SERVICE LETTER

No. 707

Subject: Modified Flyball Assembly to Improve RPM Control
-- reference attached Hartzell Service Letter No. 75,
dated November 16, 1973.

SERVICE LETTER NO. 75

A-153(A)-(C) FLYWEIGHT (SEE CHART)
(MATERIAL GROUND FROM
SIDES ON "A" MODIFICATION)

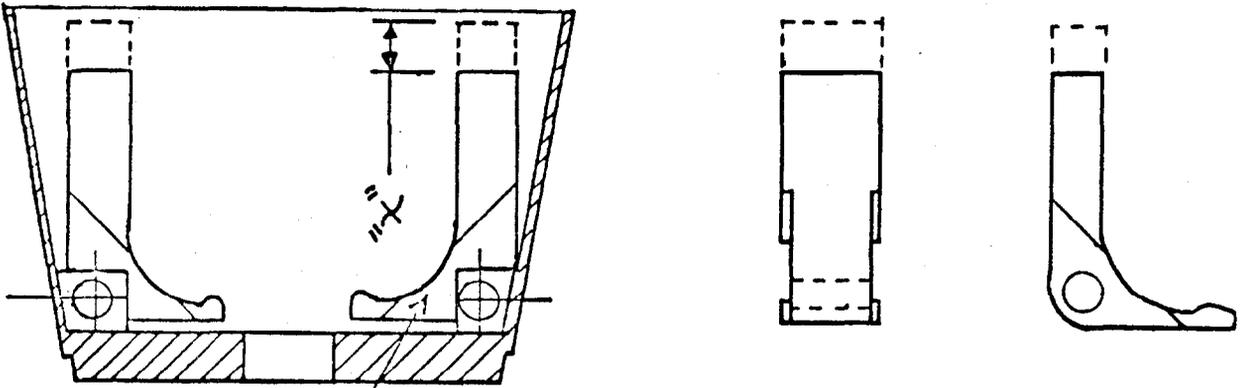
Discussion: To effect an improved RPM control on aircraft with the Hartzell governors, a modified flyweight assembly designed to absorb the torsional motions of the drive gear are being installed in all Hartzell production governors.

- 1) Determine flyweight assembly needed using parts listed in this letter.
- 2) The flyweight assembly can be changed by:
 - a) removing cover assembly
 - b) removing flyweight assembly locking ring
 - c) removing flyweight assembly
 - d) placing new flyweight assembly in place
 - e) replacing lock ring, making sure it is in place
 - f) replacing cover gasket 50672, and
 - g) installing cover assembly
